Groundwater Application Review Summary Form

Application # G- 19170

GW Reviewer Joe Kemper Date Review Completed: 6/30/2023

TO: Water Rights Section Date 6/30/2023
 FROM: Groundwater Section Joe Kemper
 Reviewer's Name
 SUBJECT: Application G- 19170 Supersedes review of 12/6/2021
 Date of Review(s)

Water-Level Measurements in Nearby Wells – red circle highlights water level measurement from proposed POA (DESC0052024); boxes show water level well groups above/within and below the Sisters Fault Zone (SFZ).

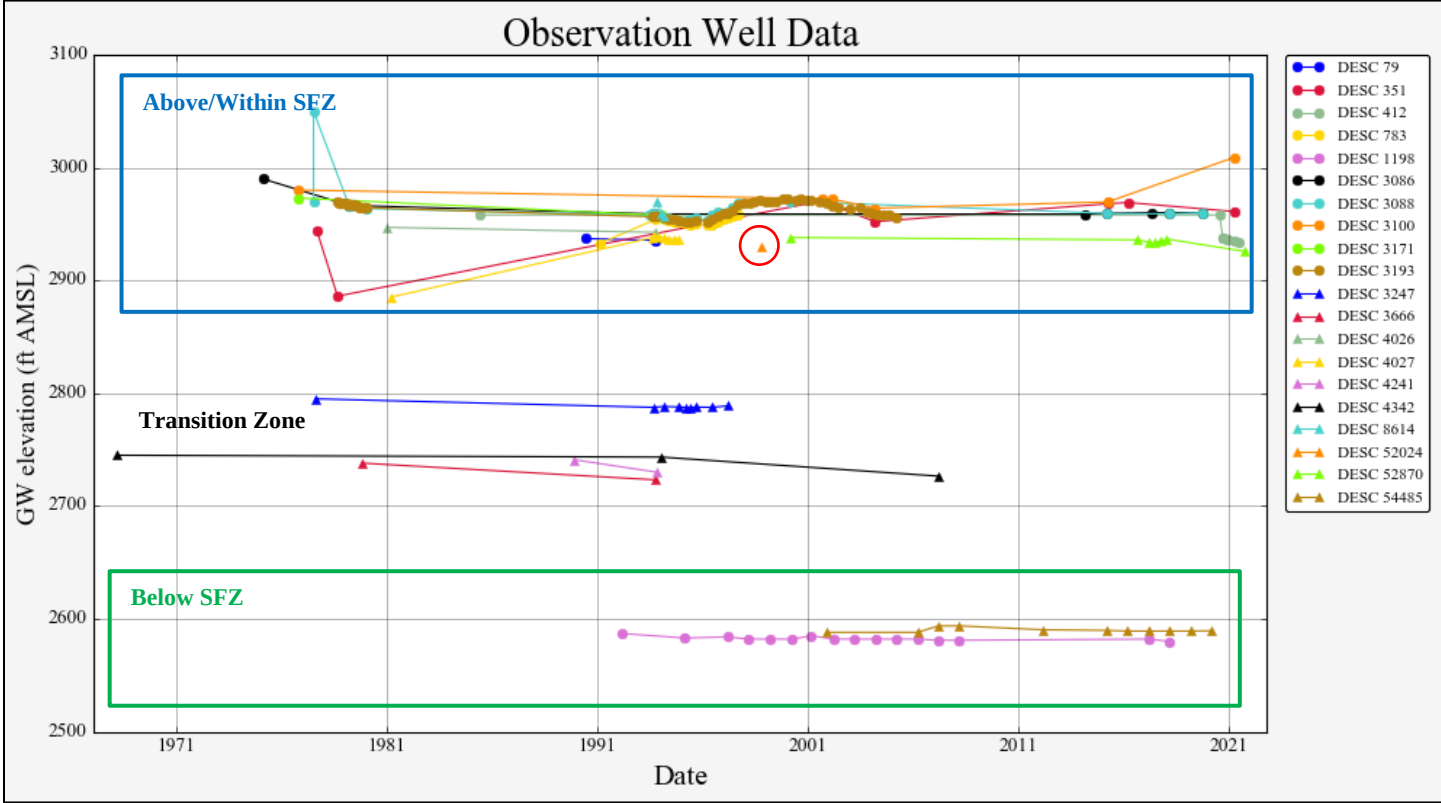
- B3. **Groundwater availability remarks:** The applicant's proposed POA would be producing from an area of the Deschutes basin that is within the Sisters Fault Zone, which is nearly 10 miles wide in this area. Water levels to the northeast of this zone generally show long-term declines while water levels to the west of this zone show water level trends resembling short- and mid-term climate cycles (annual to decadal). Water levels within this zone represent a transition. The single water level for the proposed POA is similar in elevation to water levels from wells that show climate variation and not long-term declines, so the proposed POA is assumed to be following a similar trend (but there is not sufficient water level data to definitively conclude this). Given that water level data in nearby wells do not show long-term declines, and that the applicant's POA is likely following a similar trend, there is not a preponderance of evidence that the proposed use would not be within the capacity of the resource or **targets an aquifer that is found to be over appropriated**. Despite this finding, however, groundwater flow from the area of the proposed POA is toward the northeast and into the zones of long-term declines and any new use up-gradient to this zone does have the potential to reduce flow to that zone.

- i. ☒ The permit should contain condition #(s) 7N (Annual SWL); Medium Water-Use Reporting;
 - ii. ☐ The permit should be conditioned as indicated in item 2 below.
